DRAWING AMENDMENTS

REMARKS

PATENT APPLICATION
10/720,767

FIG. 3

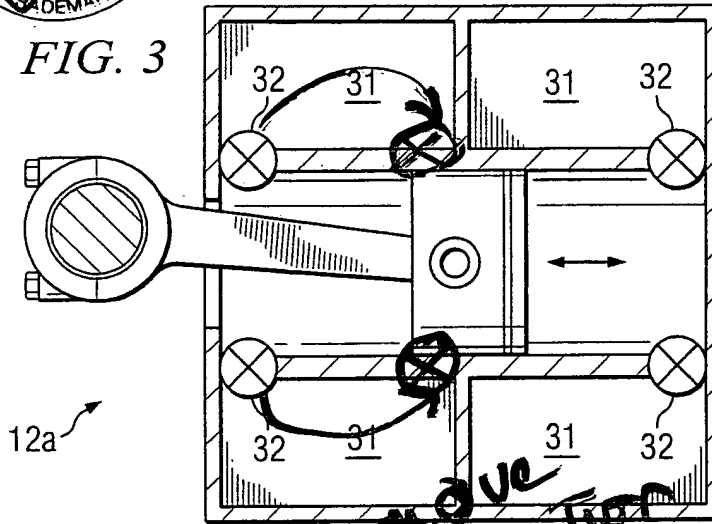
The drawings were objected to for failing to show every feature of the invention as specified in the claims. Please replace Drawing Sheets 1-2, Figures 1-4 with replacement Drawing Sheets 1-2, Figures 1-4. Applicants also submit annotated red-lined drawing pages reflecting the changes. Applicants will provide formal corrected drawings to be entered if the proposed changes are accepted by the Examiner.

Claims 1, 21, 31, and 32 were rejected by the Examiner under 35 U.S.C. §112, first paragraph, as failing to comply with the enablement requirement. Applicants have amended Figure 3 to overcome these rejections.

Claims 1, 21, 31, and 32 were rejected by the Examiner under 35 U.S.C. §112, second paragraph, as being incomplete for omitting essential elements, such omission amounting to a gap between the elements. Applicants have amended the claims to overcome these rejections. Specifically, it should be understood that the load pockets of Figure 3 are just one example of how load values can vary on a per cylinder basis.

move location of valves
